Product Change Notification

Change Notification #: 112691 - 00
Change Title: Intel® Server System R1208GZ4GC
PCN 112691-00, Product Design
Update Rear Panel
Date of Publication: November 05, 2013

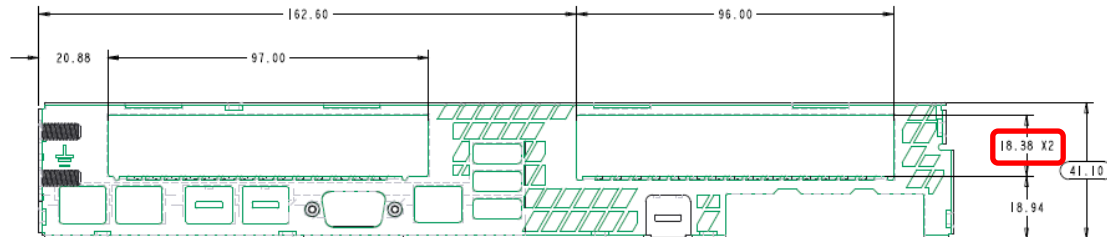
1. Update the system rear panel so that more PCIe devices and cable connectors (e.g. SFP+ PCIe card) can mechanically fit into the system. Please refer to below pictures for details:

Pre-change:

Post-change:
